STAFF ANALYSIS

Case No.: SLUP-20-1243621 **Agenda #:** N. 8

Location/Address: The property is located on the east side of Houston Mill Road, approximately 467 feet south of Lavista Road, at 1185 Houston Mill Road, Atlanta, Georgia 30329. **Commission District:** 02 **Super District:** 06

Request: For a Special Land Use Permit (SLUP) to allow a place of worship within the R-85 (Residential Medium Lot) District, in accordance with Chapter 27, Article 4, Table of the DeKalb County Zoning Ordinance.

SITE PLAN

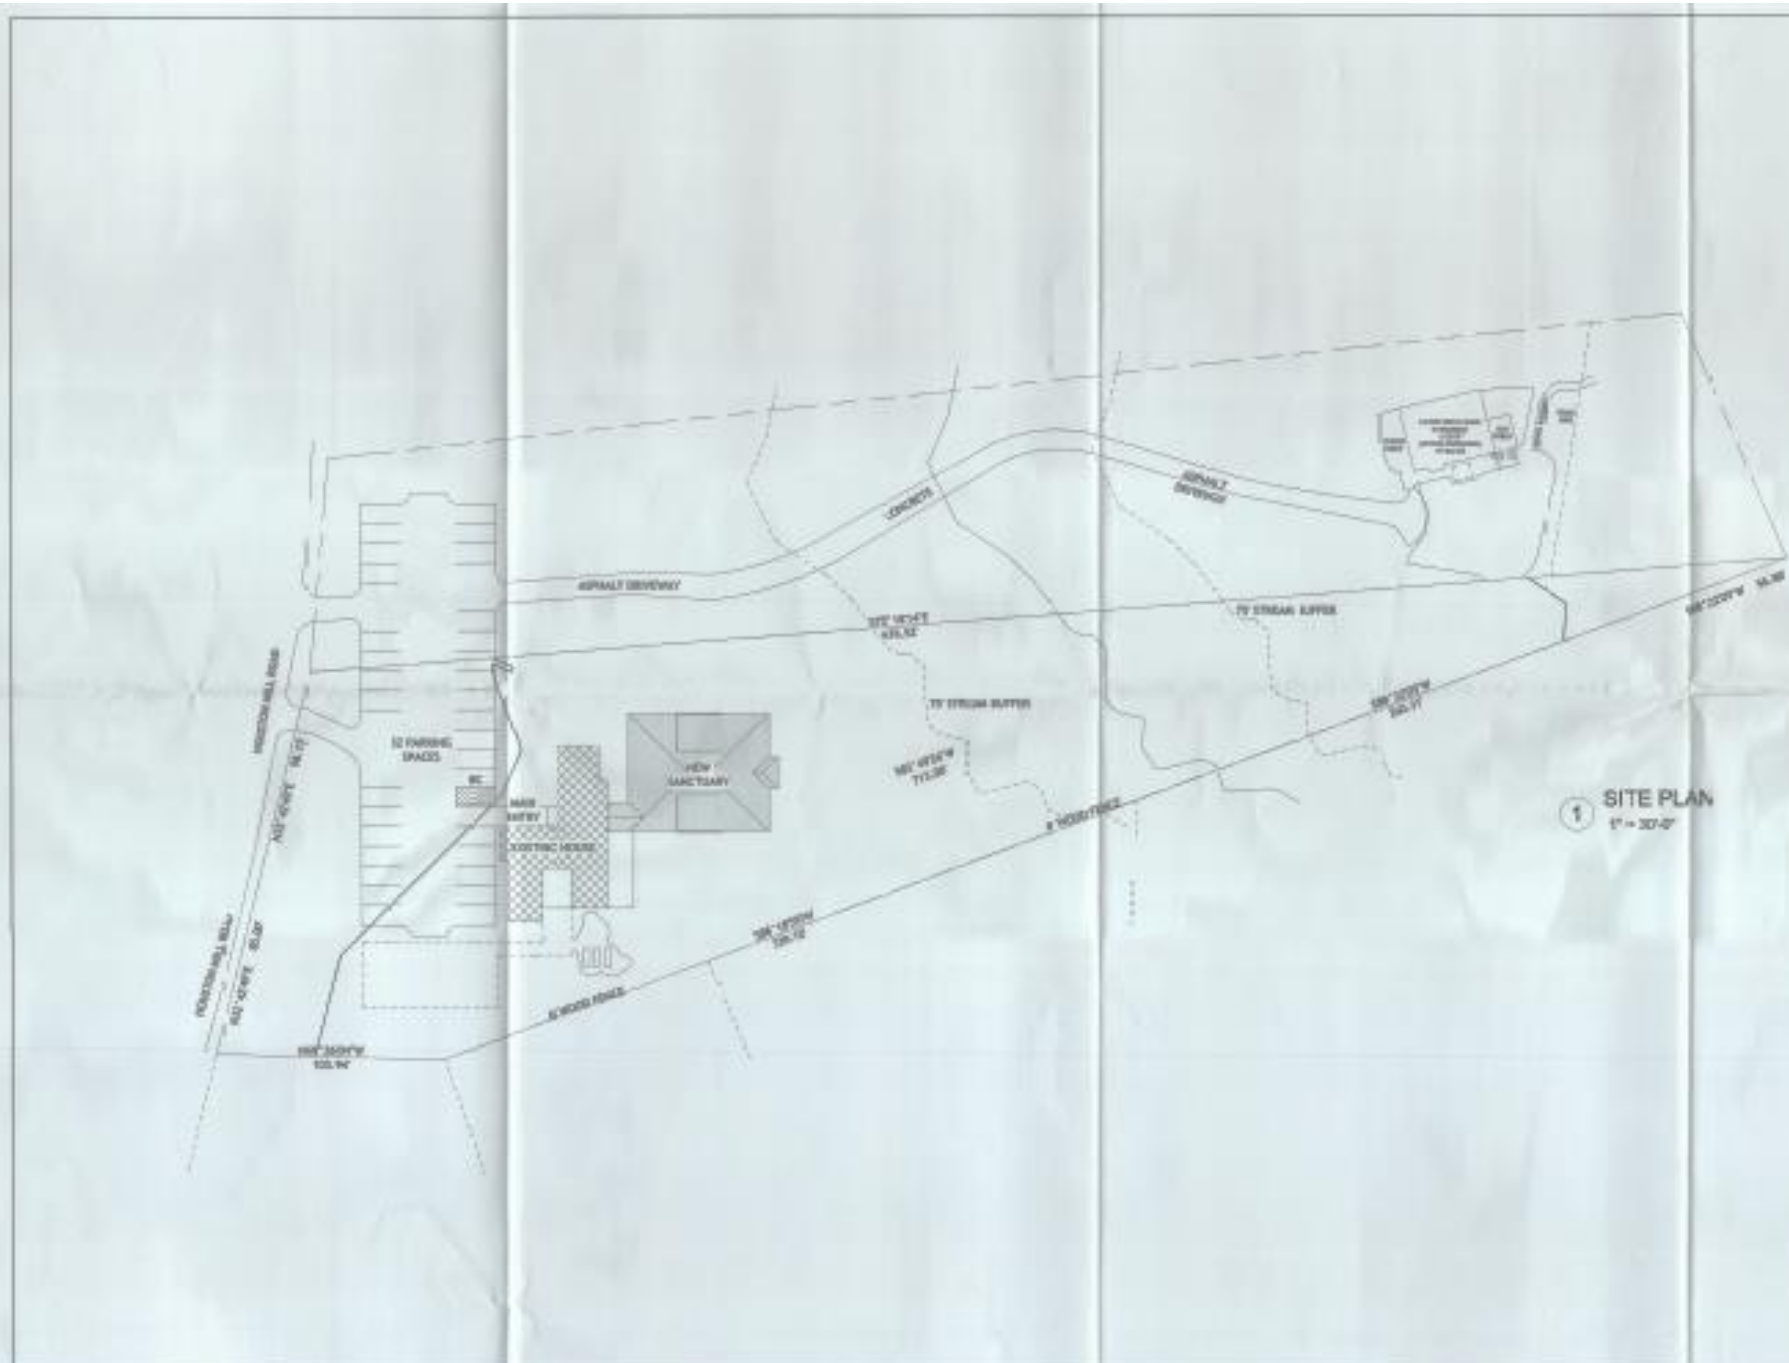
Based on the submitted site plan, the proposed place of worship does not meet this standard. The proposed place of worship is approximately 30.08 feet from the southern property that is zoned R-85 (Residential Medium Lot) District. The applicant is scheduled to go before the Zoning Board of Appeals on January 8, 2020 to request a variance from this standard.

Based on the submitted site plan, the proposed place of worship does meet this requirement.

Based on the submitted site plan, if this SLUP is granted, the proposed place of worship will meet this standard.
